**5.A PUBLIC HEARING - DRC#21-00061 - OSCEOLA VILLAGE CENTER EVEREST
REHABILITATION HOSPITAL: CONDITIONAL USE WITH SITE PLAN
(REHABILITATION HOSPITAL)**

To: City of Kissimmee DRC Response 6/15/2021
From: Richard C Wohlfarth, P.E.
Date: August 3, 2021
Re: Osceola Village Center – Rehabilitation Hospital

**RE: Everest Rehabilitation Hospital at Osceola Village Center
DRC #21-00061 - Submittal 3
CU Response to Comments**

DRAWN:	DM
DESIGNED:	DM
CHECKED:	RW
DATE:	05/03/21
SCALE:	1"=30'
PROJECT:	2021-003
SHEET:	C-3.1

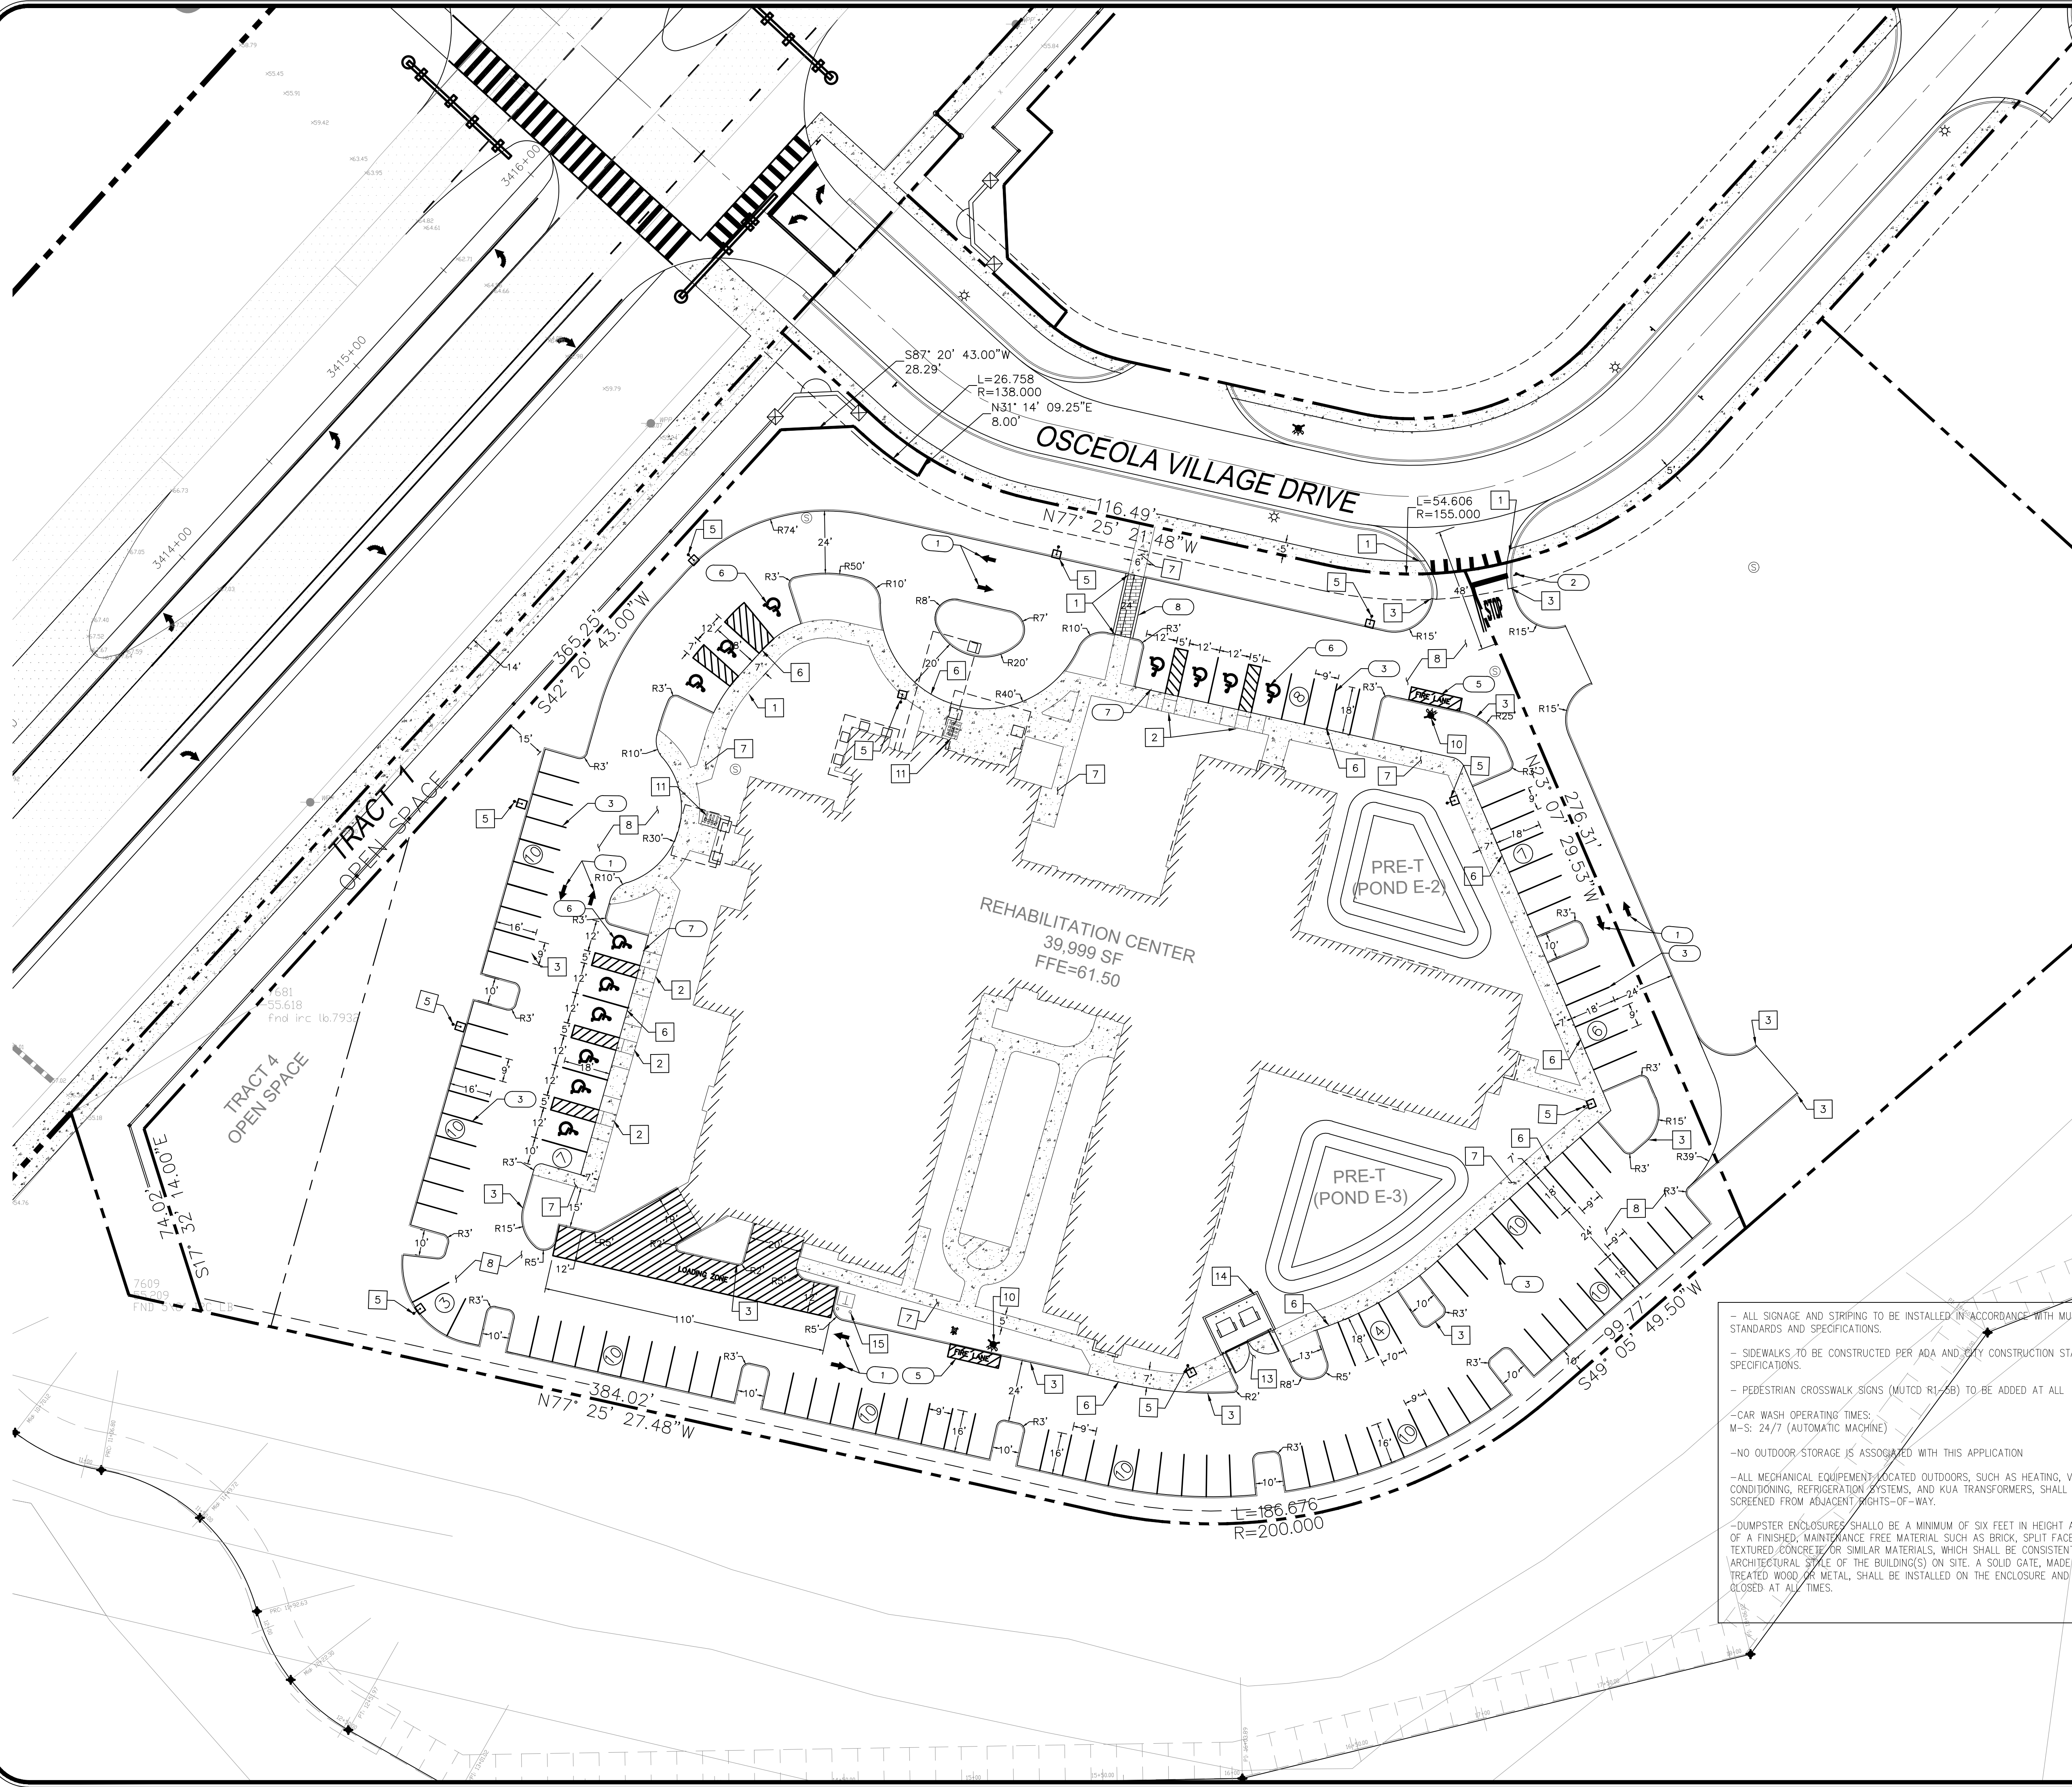
13. Sheet C-3.1 Notes: Remove car wash operating times. This project is for the hospital and not the car wash site.

RESPONSE: The note has been removed.
